Re: Self-Storage Facility
3601 Seven Bar Loop Rd. NW
Albuquerque, NM 87102
Traffic Circulation Layout
Engineer's Stamp 02-26-26 (B14D019)

Based upon the information provided in your submittal received 02-27-26, the above referenced plan cannot be approved for Building Permit until the following comments are addressed:

13. See below redline site plan:

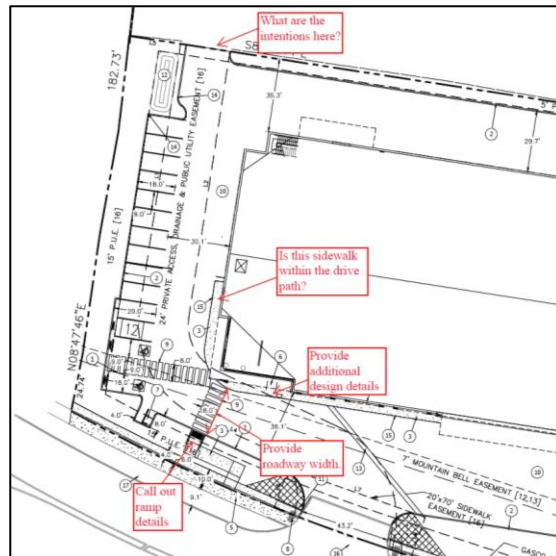
- Provide roadway width.
- Provide a bike stall design drawing in relation to the sidewalk width.
- Call out ramp details or refer to the associated key note.
- We notice key note #15. It appears that the proposed sideway falls within the drive path. Provide additional design details in regards to intentions and safety, showing a delineation between sidewalk and roadway.
- What are the intentions for the cross connectivity with the adjacent property? Provide additional design details or call out fencing.
